ADDENDUM NO. 3

VILLAGE OF OHIO CITY Storm Drainage Improvements September 7, 2016

Re: Village of Ohio City
Storm Drainage Improvements

DETENTION BASIN SITE PLAN
STORM DRAINAGE IMPROVEMENTS
THE VILLAGE OF OHIO CITY

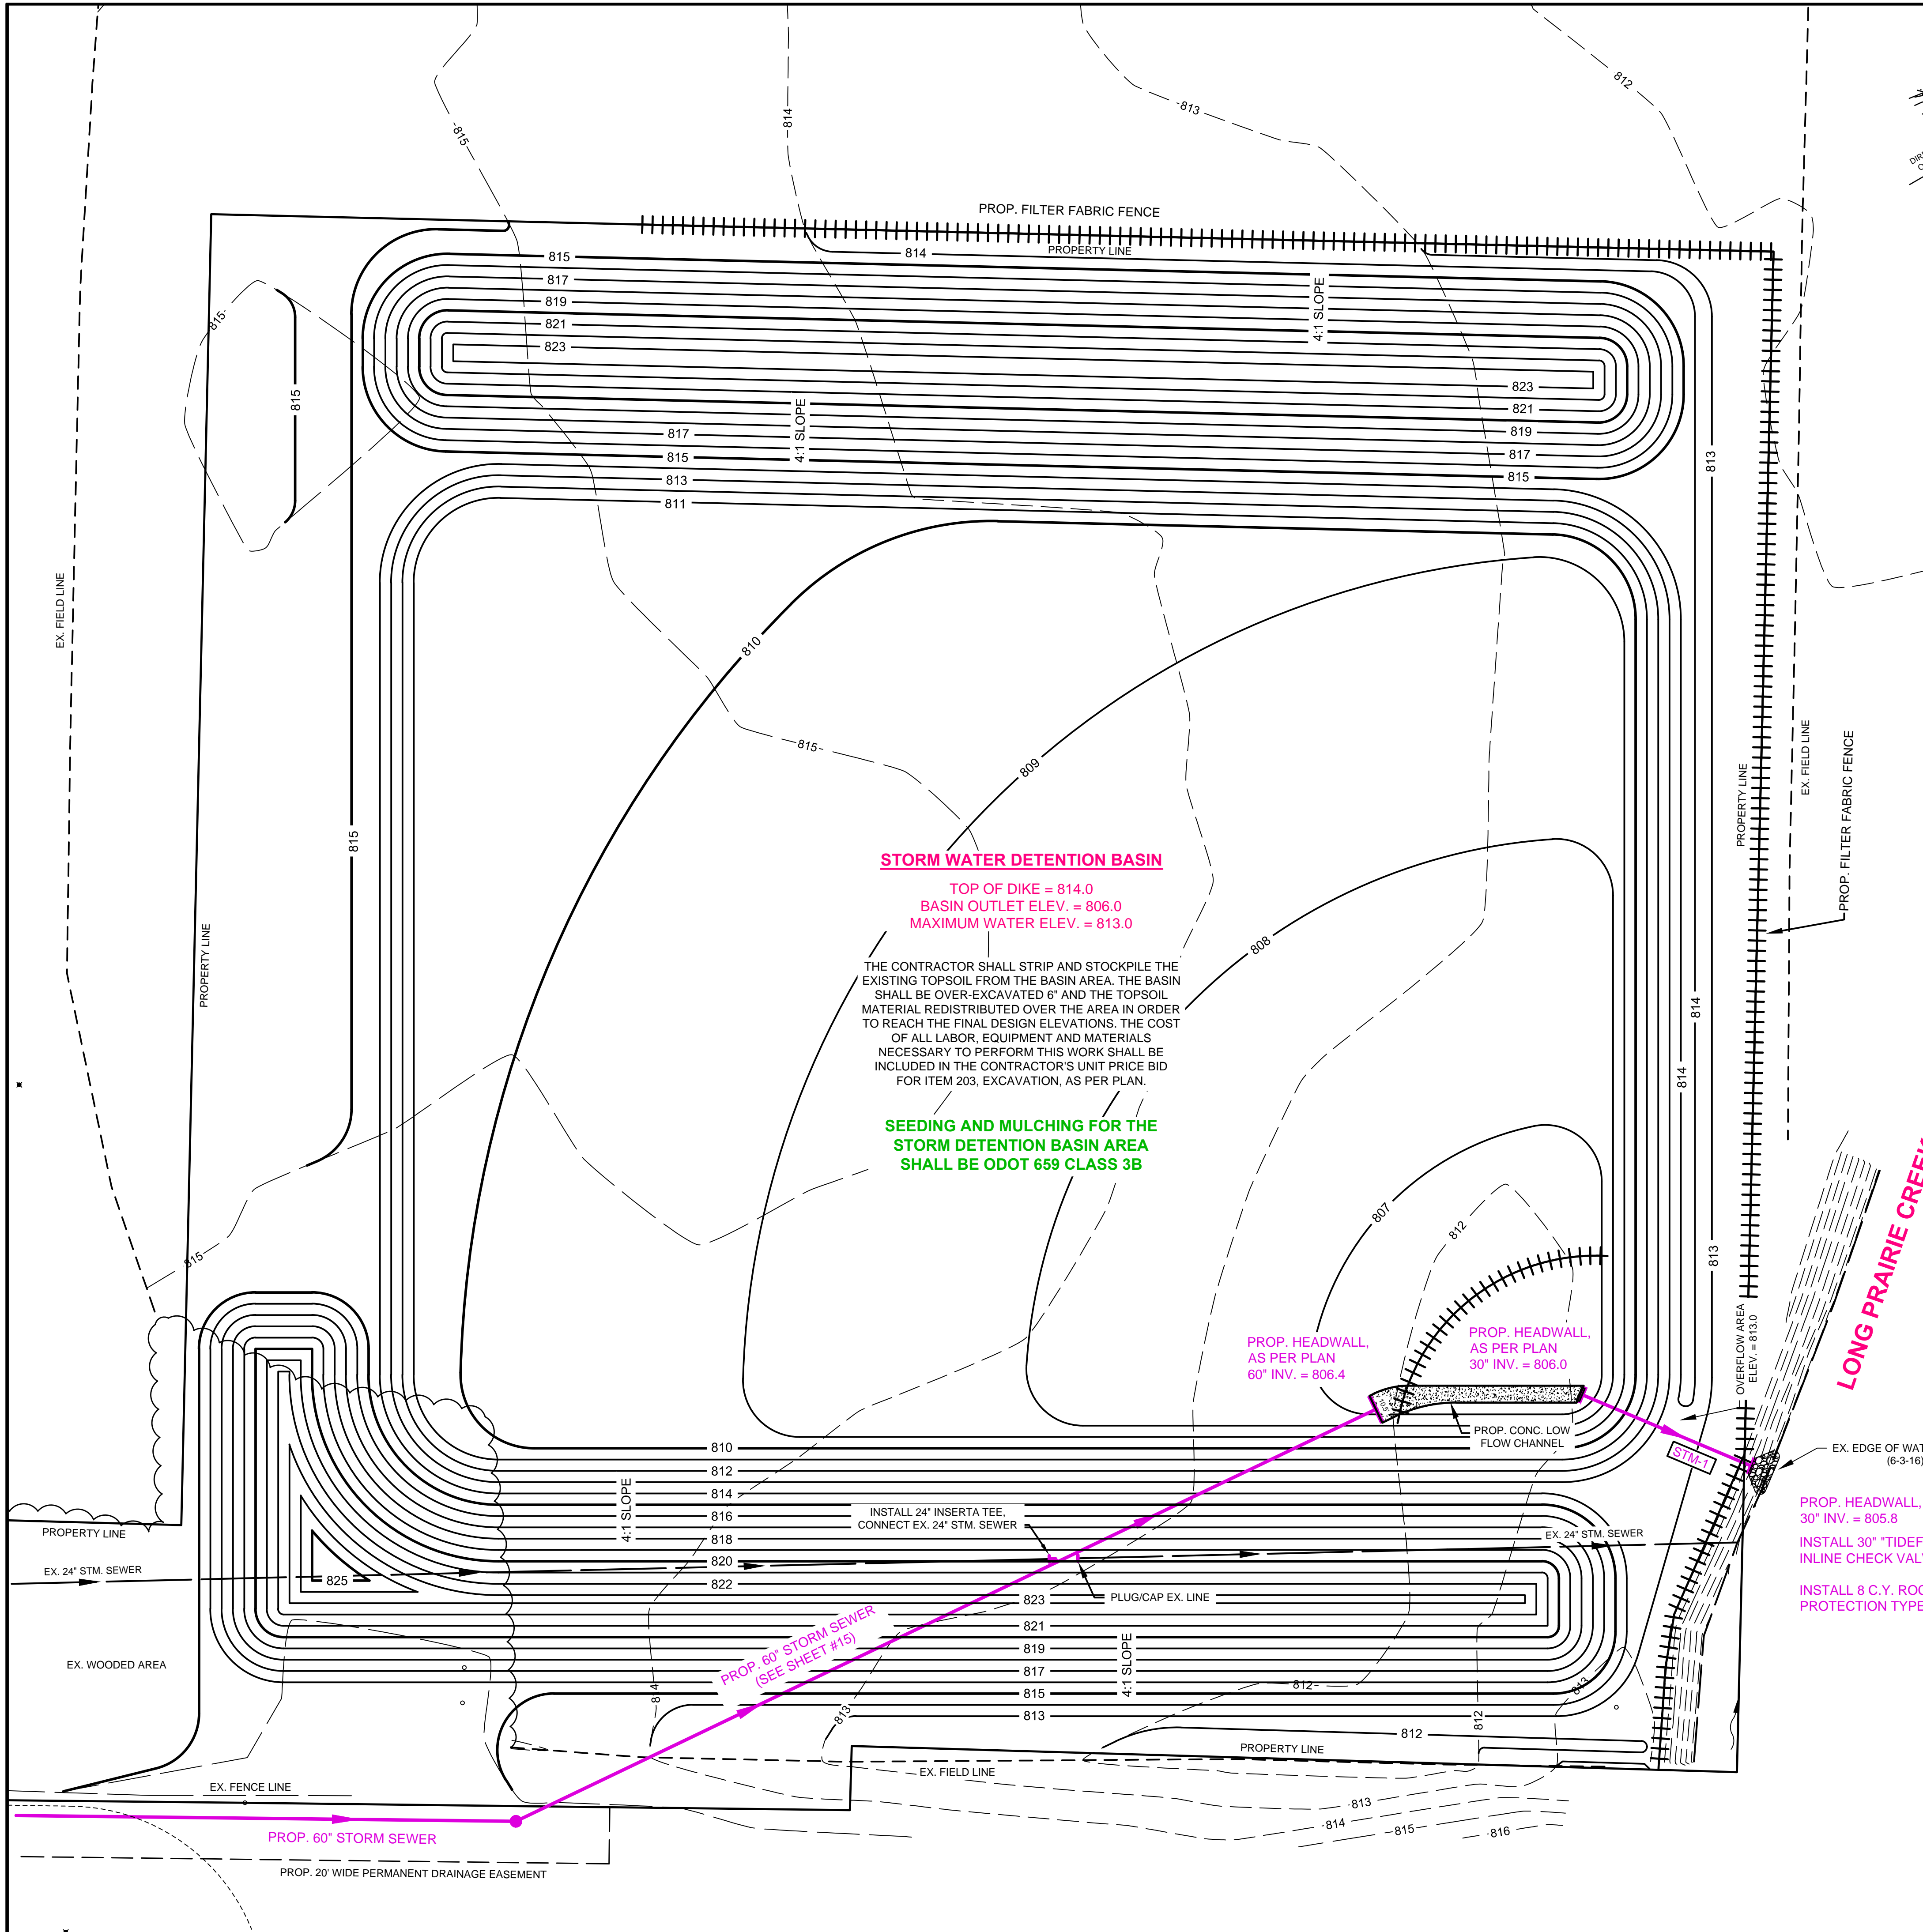
3. Sheet #6 of 23 of the Construction Plans:

This sheet has been revised to add mounding around the proposed storm water detention basin to provide a place to use part of the excess excavation without hauling offsite. A calculation of ±15,000 C.Y. of fill is estimated to be used onsite. The bid quantity for excavation has not been changed. Note #4 of the General Notes (Sheet #3/23) applies to the work. It is still the Contractor's responsibility to verify estimated earthwork quantities and to adjust their unit price bid accordingly. Payment for the earthwork will be as bid for 'Excavation, As Per Plan'.
